**DEVIATION REQUEST
AND DECISION FORM**
Updated: 6/26/2019

Project Name : The Commons at Falcon Field Deviation No. 1 Date: 11/27/2023 rev. 2/9/2024, **4/3/2024**

DEVIATION No. 1 – Intersection Spacing (Rev. 4/3/2024; 2/9/2024; 11/17/2023; 6/2/2023; Original 1/4/2020): A deviation from the standards of or in Sections **2.2.5.D** and **2.3.2** of the Engineering Criteria Manual (ECM) is requested. The request is for – **Part 1a:** a full-movement, roundabout intersection on a proposed Non-Residential Collector street 580 feet south of the Woodmen Road/US Highway 24 intersection (centerline spacing – estimated, following widening of US Highway 24 to four lanes). **Part 1b:** [No longer needed due to plan adjustment]. This revised deviation no longer references "Parts 1a and 1b."

Deviation Exhibit 1-1
Intersection Spacing
Commons at Falcon Field (LSC# 234220)

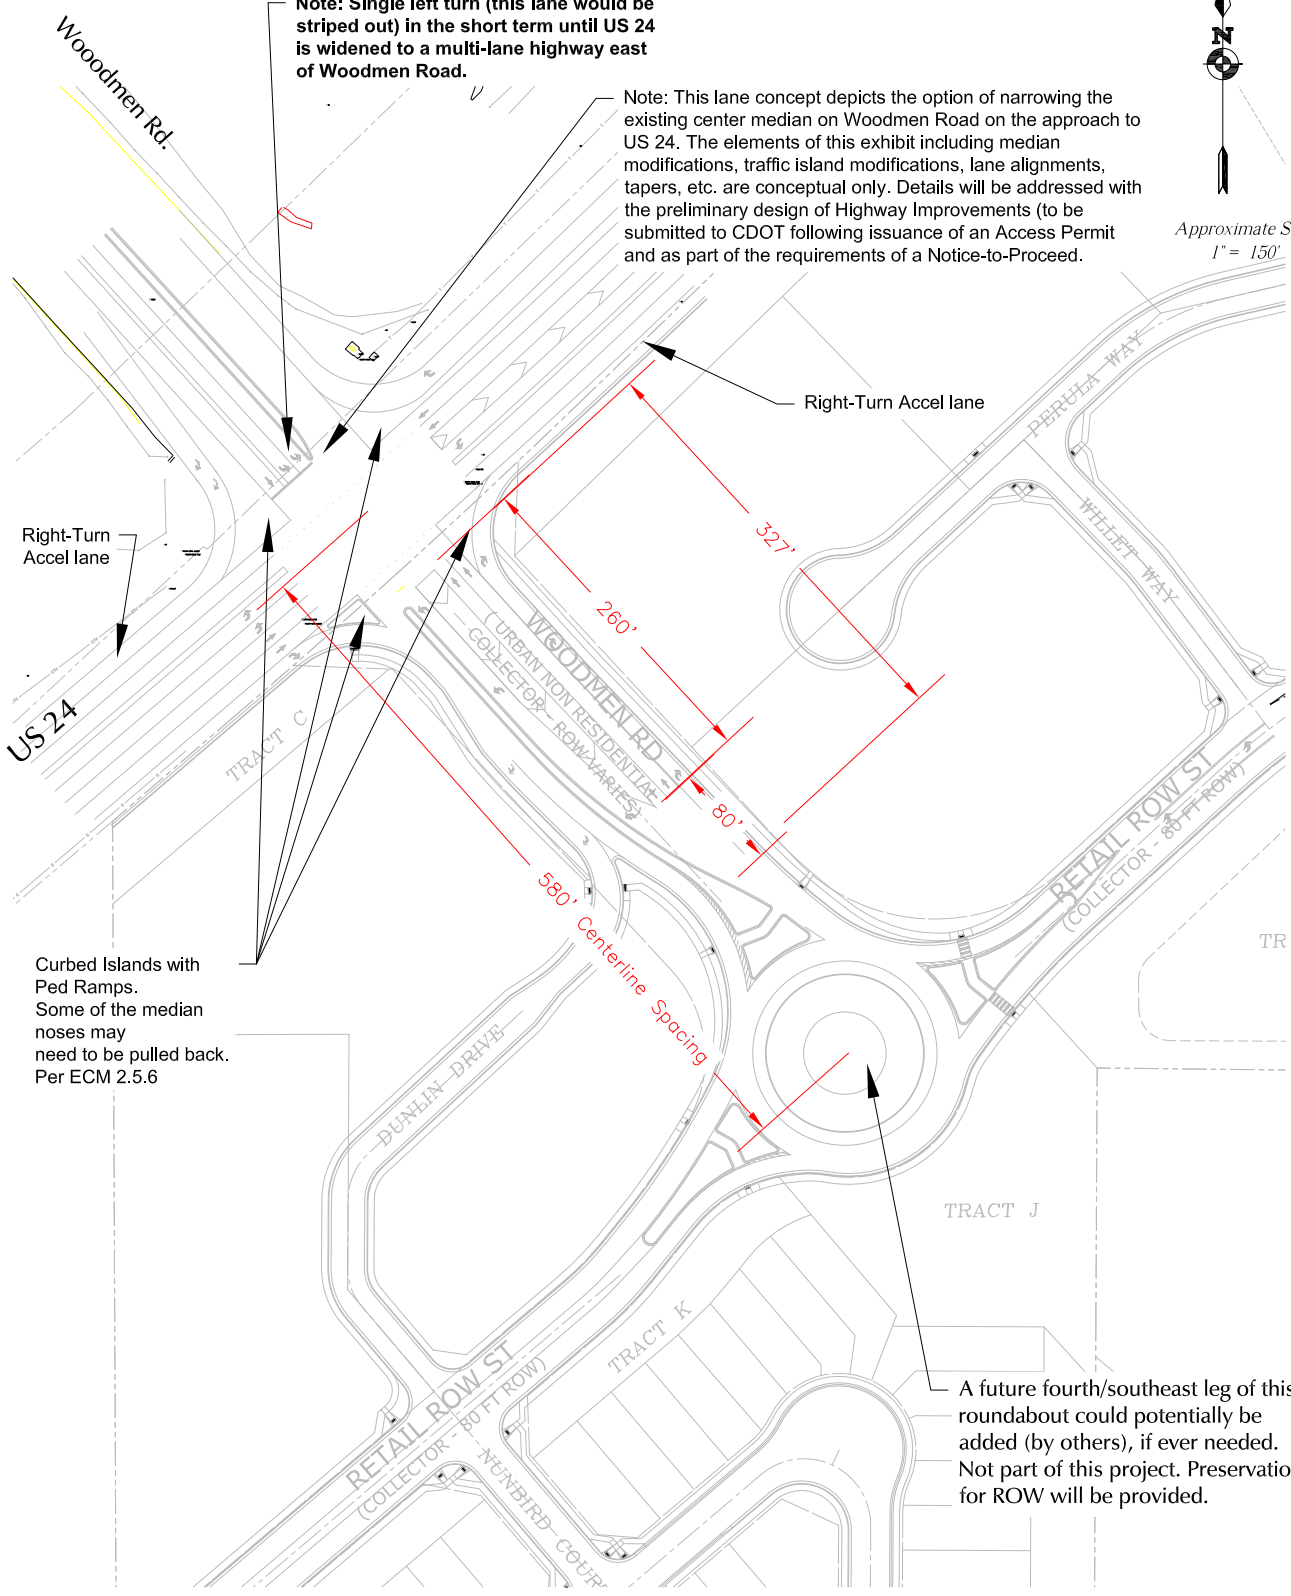
The standard indicates a minimum of 660 feet intersection spacing along Urban Non-Residential Collectors. The request would be for an intersection spacing of approximately 580 feet between the US Highway 24/Woodmen Road intersection and the new intersection with Retail Row Street (estimated, following the future widening of US Highway 24 to four lanes). Please refer to the attached Deviation Exhibit 1-1.

The CDOT comment memo dated May 5, 2023 did not indicate that this proposed spacing from the US Highway 24/Woodmen Road needed would be unacceptable. Our understanding from prior meetings with CDOT and comment letters is that this spacing is acceptable to CDOT with the conditions/requirements outlined in the comment memo. The proposed spacing exceeds 300 feet from the end of the radius at the intersection of US Highway 24/Woodmen.

Proposed public street intersection spacing along a Non-residential Collector 660' required, 580' proposed.

This request has been determined to have met the criteria for approval. A deviation from Section [2.2.5.D, & 2.3.2](#) of the ECM is hereby granted based on the justification provided.

County approvals are conditional on CDOT approval.

Deviation Exhibit 1-2

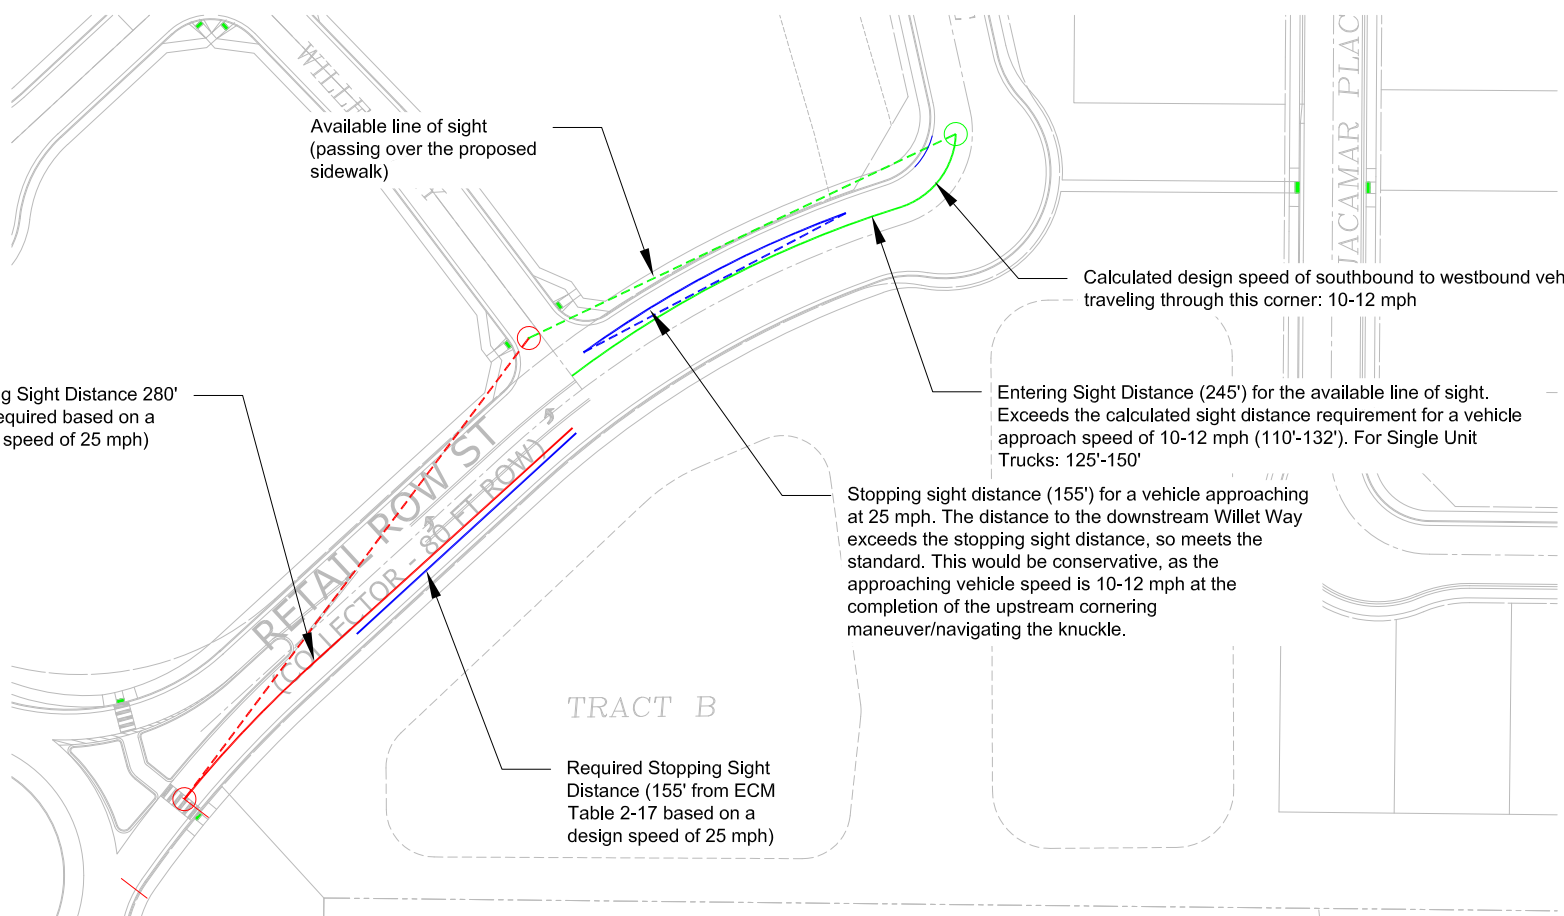
The spacing of 580 feet allows for necessary turn lanes and storage at the US Highway 24/Woodmen Road intersection. These lanes are shown in Deviation Exhibit 1-2 and the lane lengths are a separate deviation request (Deviation Request No. 3). The roundabout at the main internal intersection ensures that there will not be excessive queuing to impact the US Highway 24/Woodmen Road intersection. The cross section includes additional lanes to reduce the potential overall queue lengths within this 602-foot distance. Please refer to Deviation Exhibit 3-3, which presents the results of the queuing analysis.
